**[Docket No. FAA-2023-0922; Project Identifier AD-2022-01431-T]**

#### **Airworthiness Directives; The Boeing Company Airplanes**

**ACTION:** Notice of proposed rulemaking (NPRM).

**SUMMARY:** The FAA proposes to supersede Airworthiness Directive (AD) 2022-06-16, which applies to all The Boeing Company Model 747-100, 747-100B, 747-100B SUD, 747-200B, 747-200C, 747-200F, 747-300, 747-400, 747-400D, and 747-400F series airplanes. AD 2022-06-16 requires revising the limitations and operating procedures sections of the existing airplane flight manual (AFM) to incorporate specific operating procedures for takeoff, instrument landing system (ILS) approaches, non-precision approaches, and go around and missed approaches, when in the presence of 5G C-Band interference as identified by Notices to Air Missions (NOTAMs). Since the FAA issued AD 2022-06-16, the FAA determined that additional limitations are needed due to the continued deployment of new 5G C-Band base stations whose signals are expected to cover most of the contiguous United States at transmission frequencies between 3.7-3.98 GHz. This proposed AD would require revising the limitations section of the existing AFM to incorpo

**Figure 1 to paragraph (g)(2)(i) – *Fundamental Effective Isotropic PSD at Outside Interface of Aircraft Antenna***

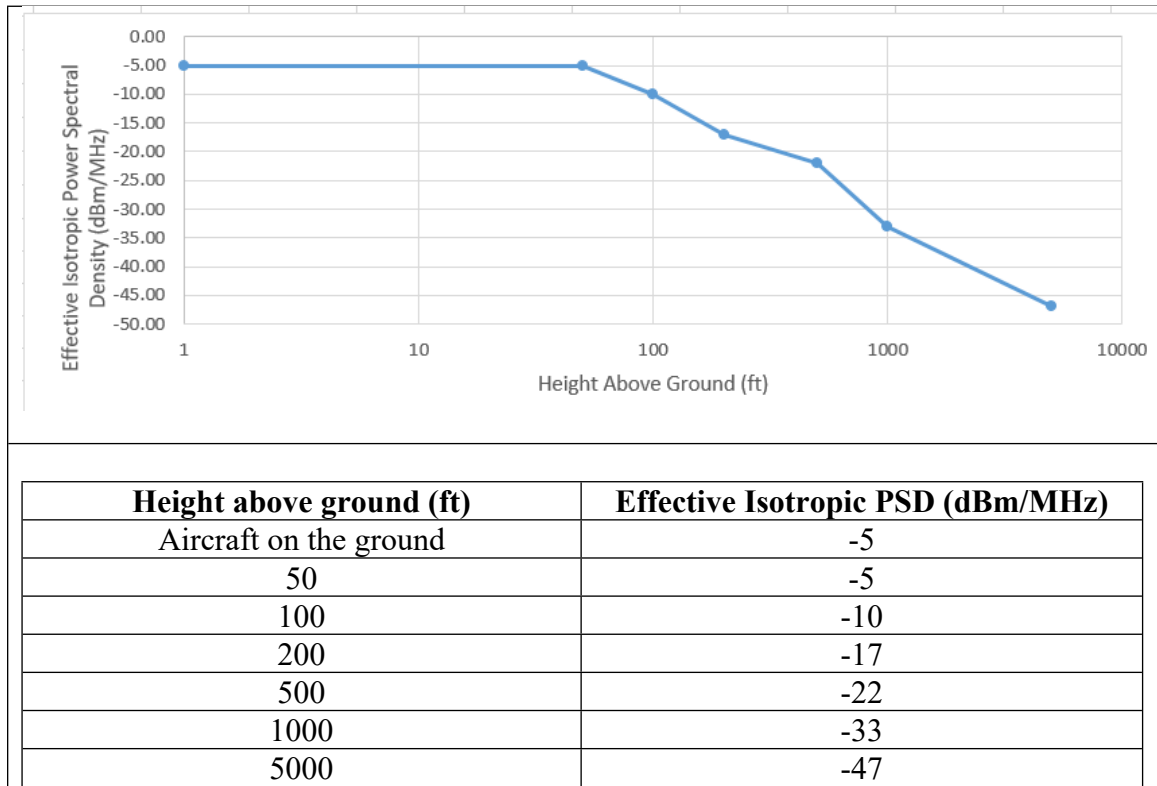
(i) Tolerance to radio altimeter interference, for the fundamental emissions (3.7-3.98 GHz), at or above the power spectral density (PSD) curve threshold specified in figure 1 to paragraph (g)(2)(i) of this AD.

**Figure 2 to paragraph (g)(2)(ii) – Spurious Effective Isotropic PSD at Outside Interface of Aircraft Antenna**

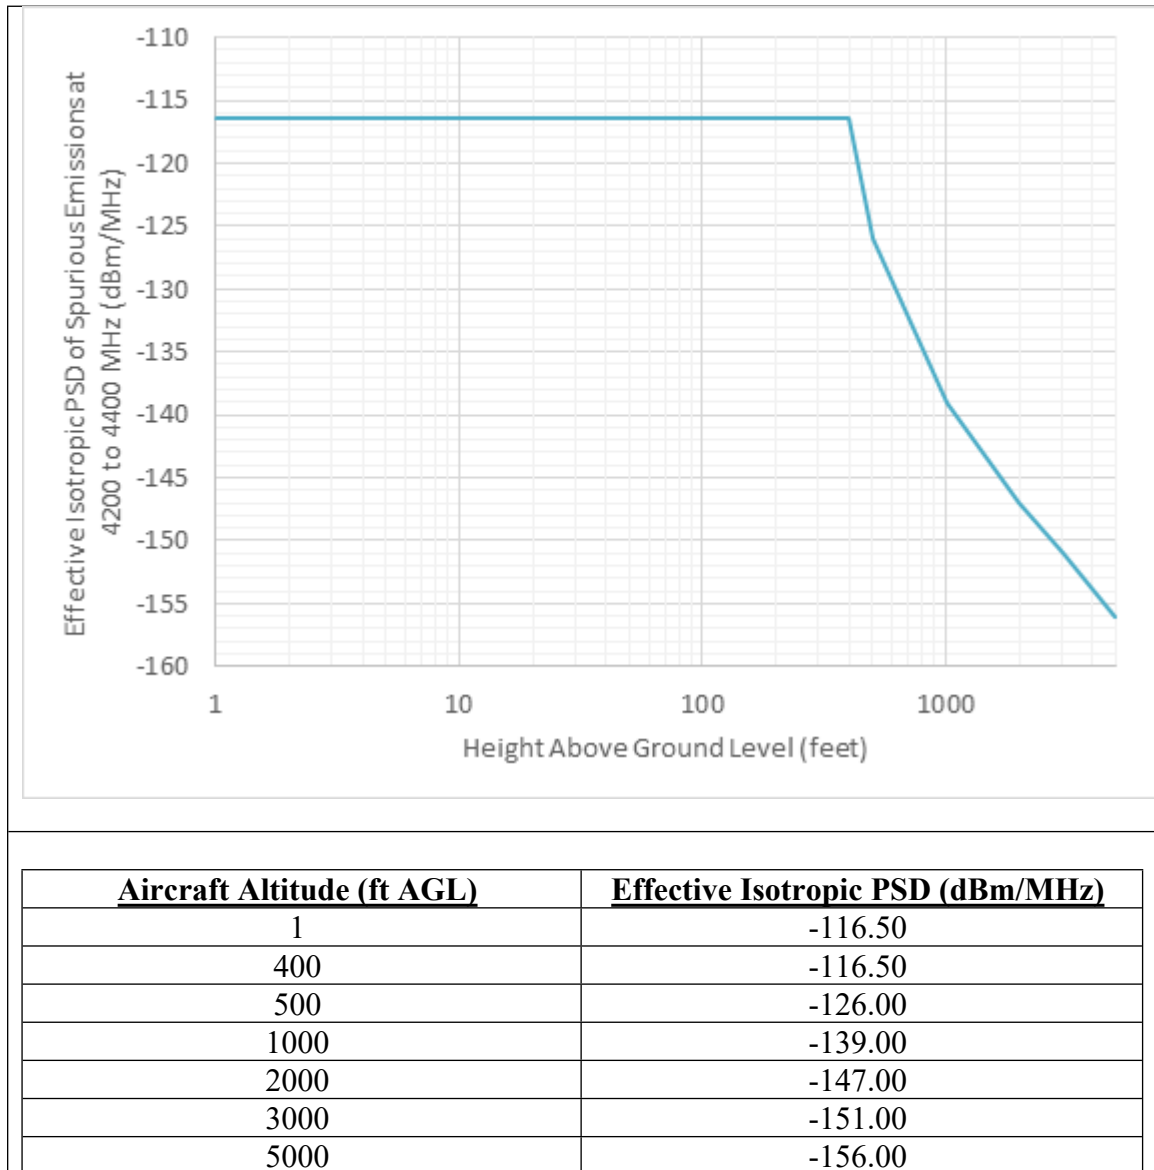
(ii) Tolerance to radio altimeter interference, for the spurious emissions (4.2-4.4 GHz), at or above the PSD curve threshold specified in figure 2 to paragraph (g)(2)(ii) of this AD.
